PERCOLATION CERTIFICATION PLAN

GAITHER HUNT

SECTION 2
LOTS 73 THRU 77

RE: Grading Plan 01-188
Gaither Hunt Lots 76 & 77
Dorsch Farm Road

DATE	<u>2-5-02</u>	JOB NO.	<u>61206</u>
ATTENTION	<u>BON PINKLEY</u>		
RE:	<u>Gaither HUNT</u>		
	<u>Lot 77</u>

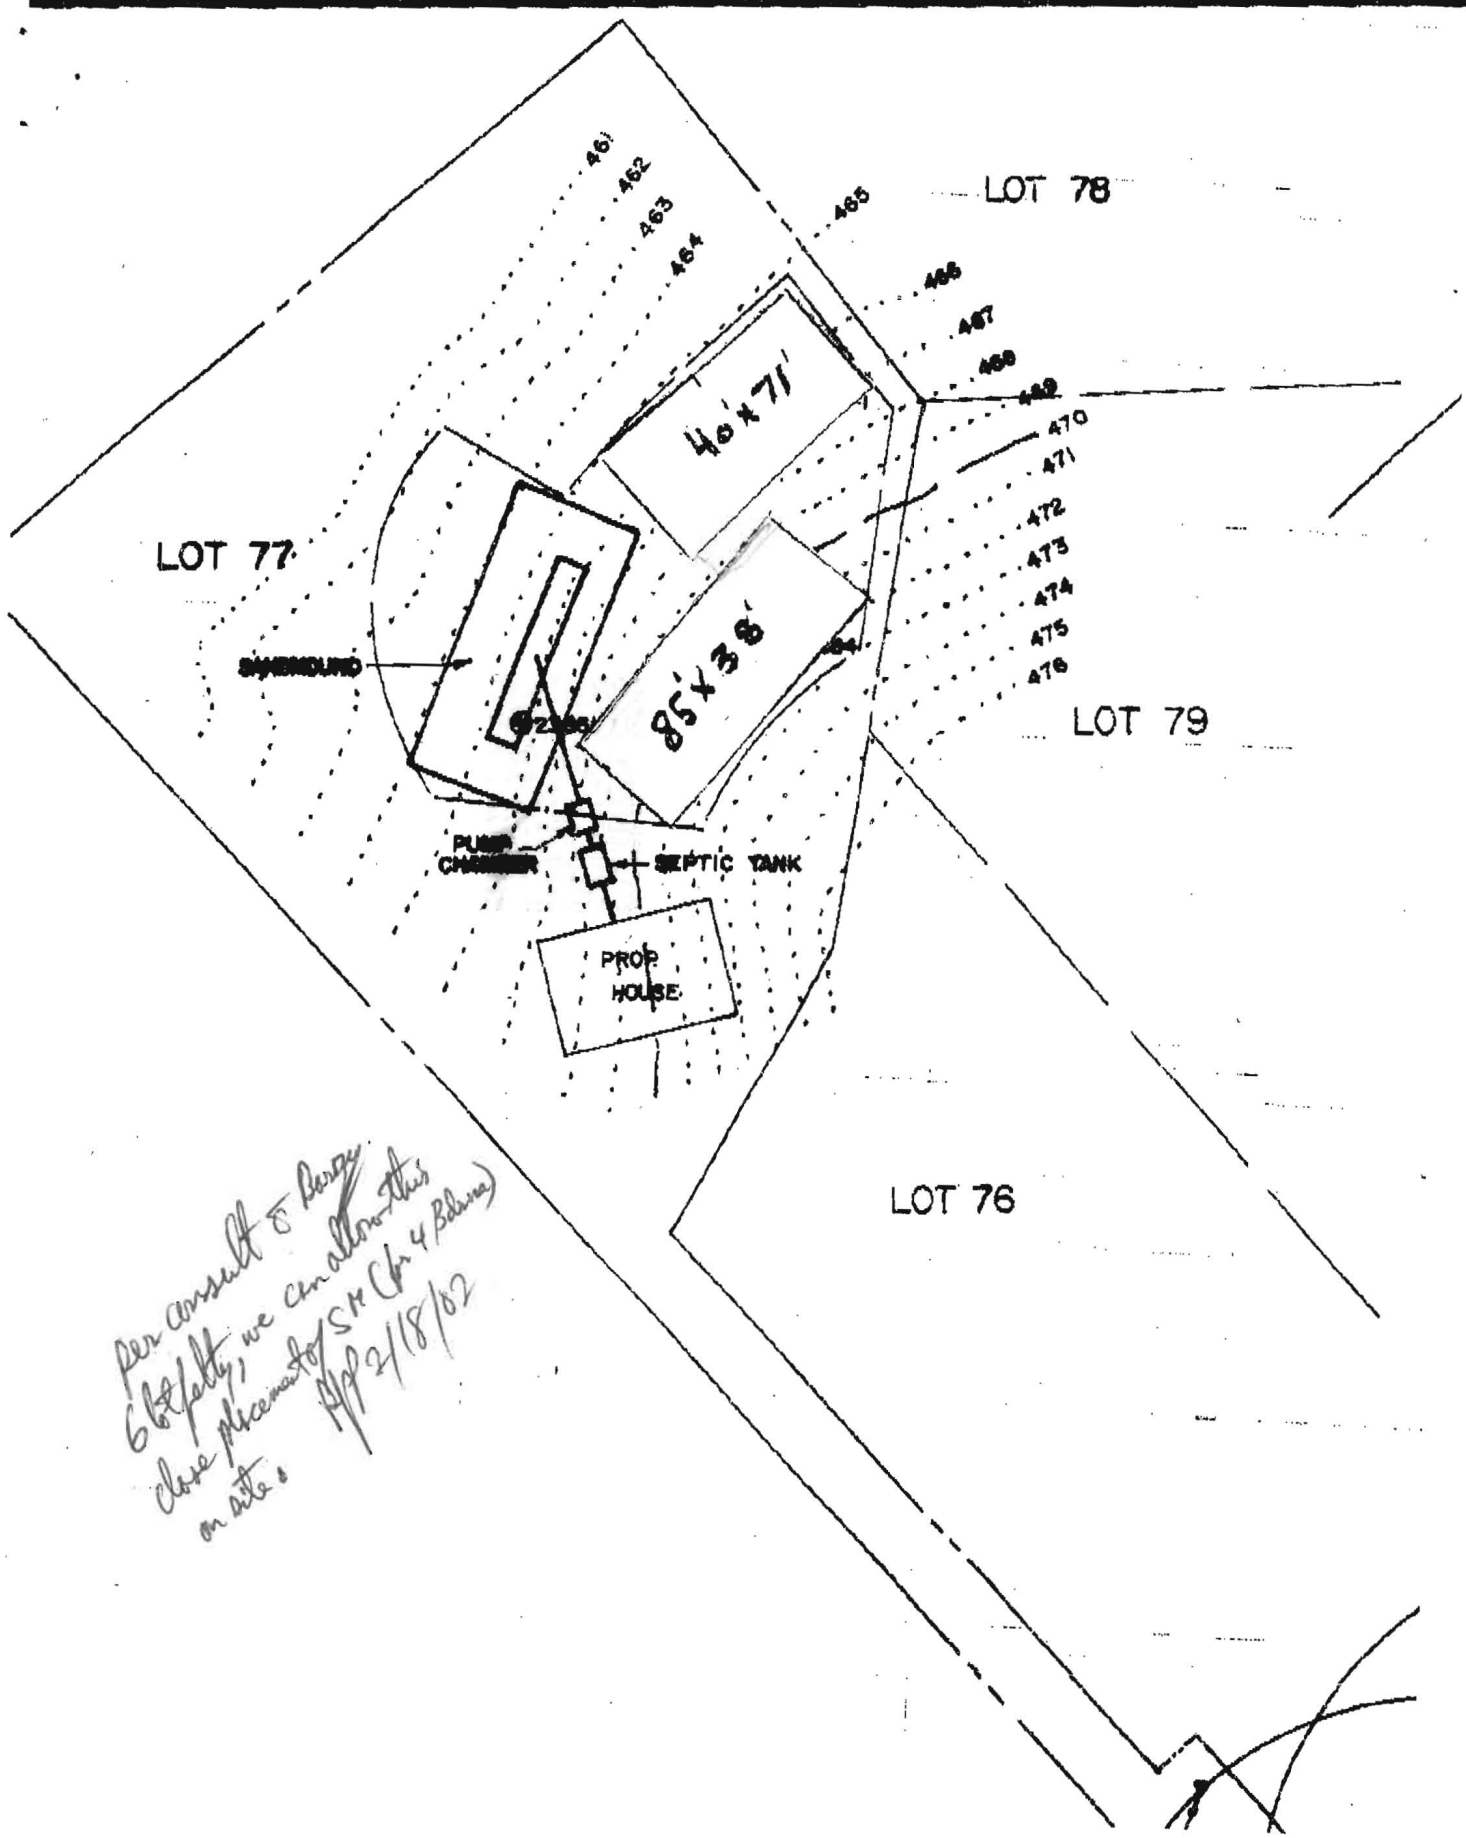
*per consult to Perry
 6/2/02, we can allow this
 close placement of SH (for 4 Bedrooms)
 on site.
 APP 2/18/02*

LOT 77
GAITHER HUNT
2 RESERVE SITES
(410) 313-2648

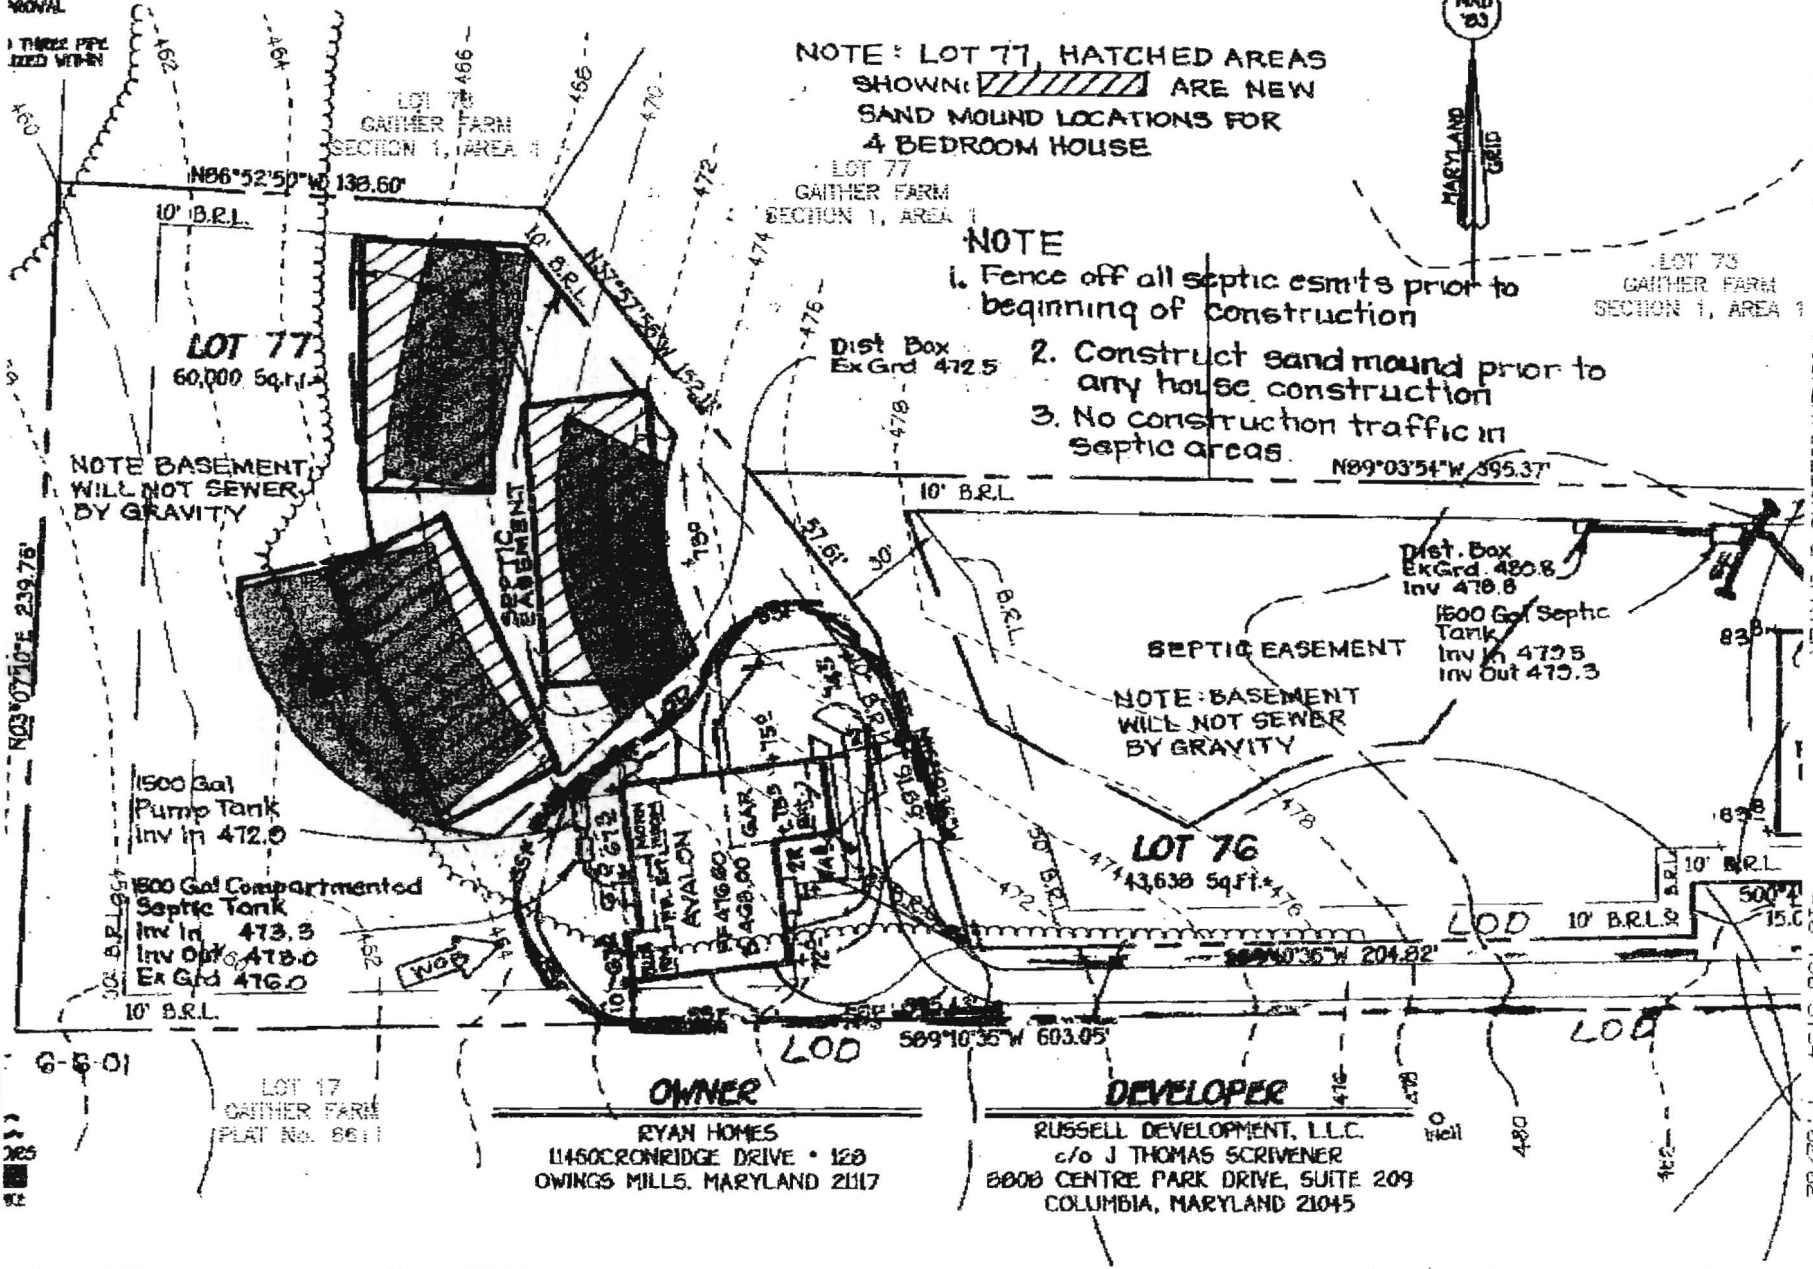
The revised section, which showed three sand mound footprints all within the previously approved Sewage Disposal Area, was acceptable. The sand mound footprints were all sized for a 4-bdrm house. However, there are a number of changes needed before this becomes a workable plan. These items needing changes are listed below:

- The elevations for septic tank and pump chamber are incorrect. Those given are 10-ft. above shown grade at the referenced site.
- Delete the reference to a distribution box. Sand mound systems don't use them.

- During all phases of grading and construction, fencing shall be erected around the SDA and SM sites. This fencing must extend a minimum of 10-ft. beyond the upslope side, 15-ft beyond the side slope and 20-ft beyond the down slope of each SM footprint wherever the SDA line shows a lesser distance (except where limited by a property line).

- The LOD line is too close to the SDA and SM footprints. LOD silt fencing may not be set any closer to the sand mound footprints than as mentioned in fencing of SM's and SDA above.

- The house is shown too close to the SDA and SM footprints. A minimum 20-ft separation distance is expected here.
- Grading and cutting activities (such as manmade swales or drainage pathways, which require a 25-ft. minimum separation) shall be properly spaced from the initial and two replacement sand mound footprints.

- Septic tank and pump chamber placement must also be at least 20-ft. from any sand mound footprint, unless it can be demonstrated such placement will not adversely affect the proper functioning and maintenance of the sand mound system.

- The proposed house footprint severely constrains access-ways around the house to the South (10-ft. to property line and wooded) and East (25-ft to property line and over a proposed cut and fill terrace) as well as between the SDA, septic tank/pump chamber and Northwest house corner. Such site restrictions severely limit the movement of construction equipment and material between sand, gravel and soil stockpiles sites (if any) and any available side or upslope SM construction staging areas.

- The two replacement sand mounds are close to adjacent property lines, limiting access for their respective construction operations. I suggest adding a statement near the property lines in common with lots 79 (misidentified as lot 77 on this plan) and 78. This statement should declare

- Done • The elevations for septic tank and pump chamber are incorrect. Those given are 10-ft. above shown grade at the referenced site.
- Done • Delete the reference to a distribution box. Sand mound systems don't use them.

- Note • During all phases of grading and construction, fencing shall be erected around the SDA and SM sites. This fencing must extend a minimum of 10-ft. beyond the upslope side, 15-ft beyond the side slope and 20-ft beyond the down slope of each SM footprint wherever the SDA line shows a lesser distance (except where limited by a property line).

- Best case → • The LOD line is too close to the SDA and SM footprints. LOD silt fencing may not be set any closer to the sand mound footprints than as mentioned in fencing of SM's and SDA above.

- The house is shown too close to the SDA and SM footprints. A minimum 20-ft separation distance is expected here. 16'
- No grading • Grading and cutting activities (such as manmade swales or drainage pathways, which require a 25-ft. minimum separation) shall be properly spaced from the initial and two replacement sand mound footprints.

- Not required • Septic tank and pump chamber placement must also be at least 20-ft. from any sand mound footprint, unless it can be demonstrated such placement will not adversely affect the proper functioning and maintenance of the sand mound system.

- Yes we know so • The proposed house footprint severely constrains access-ways around the house to the South (10-ft. to property line and wooded) and East (25-ft to property line and over a proposed cut and fill terrace) as well as between the SDA, septic tank/pump chamber and Northwest house corner. Such site restrictions severely limit the movement of construction equipment and material between sand, gravel and soil stockpiles sites (if any) and any available side or upslope SM construction staging areas.

- Not required • The two replacement sand mounds are close to adjacent property lines, limiting access for their respective construction operations. I suggest adding a statement near the property lines in common with lots 79 (misidentified as lot 77 on this plan) and 78. This statement should declare
